APPLICATION NO.	FILING DATE	FIRST NAMED INVENTOR	ATTORNEY DOCKET NO.	CONFIRMATION NO.
09/804,012	03/12/2001	William R. Bennett	SP-1080.2 US	8880

Office Action Summary

DETAILED ACTION

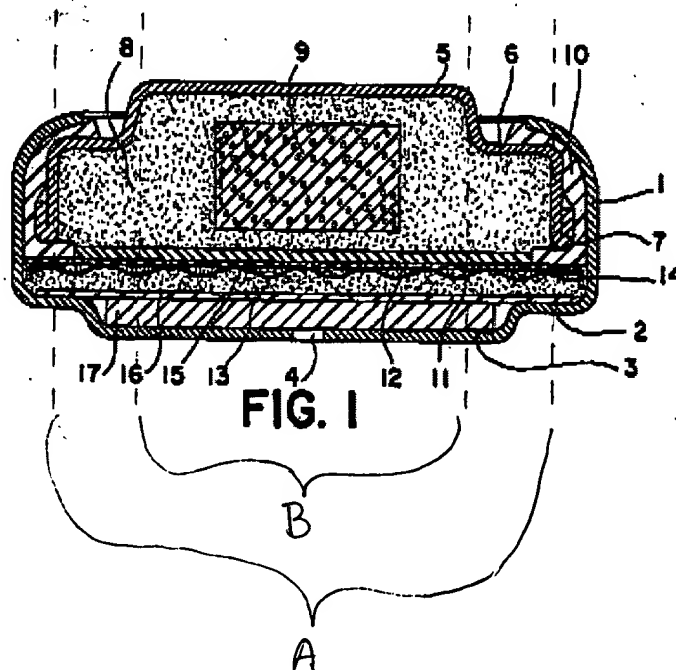
Claim 5 is rejected under 35 U.S.C. 102(b) as being anticipated by Sauer et al. (U.S. Pat. 4,054,726).

Regarding independent claim 5, Sauer et al. teaches an anode cup having a closed upper end [5], an open lower end [8], a step and a substantially vertical section between the step and the closed end. (Figure 1) Figure 1 is relied upon to teach, by illustration, that the internal diameter [A] of the open end is larger than the maximum external diameter [B] above said step.

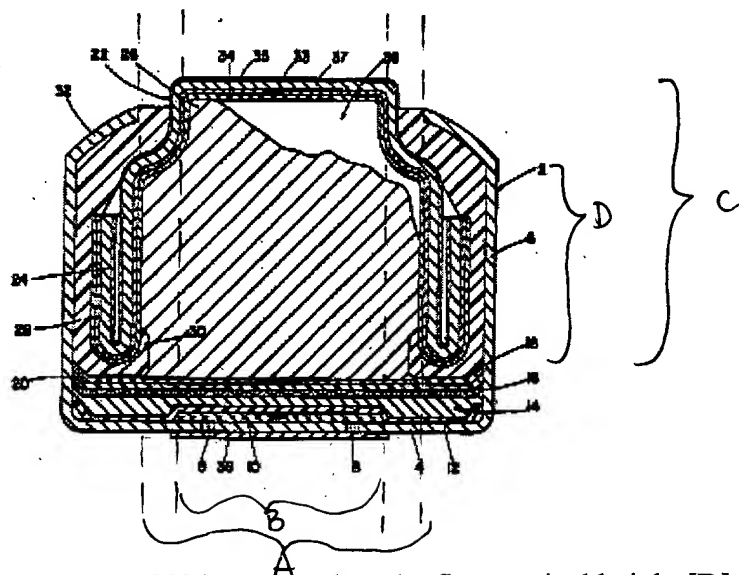
Claims 5 and 7 are rejected under 35 U.S.C. 102(b) as being anticipated by Mansfield, Jr. et al. (U.S. Pat. 5,279,905).

Regarding independent claims 5 and 7, Mansfield, Jr. et al. teaches an anode cup having a closed upper end [37], an open lower end [36], a step and a substantially vertical section between the step and the closed end. (Figure) The Figure is relied upon to teach, by illustration, that the internal diameter [A] of the open end is larger than the maximum external diameter [B] above said step, as illustrated below:

As shown, the second vertical height [C] is greater than the first vertical height [D] and thus the resulting difference would be greater than zero. (independent claim 7)
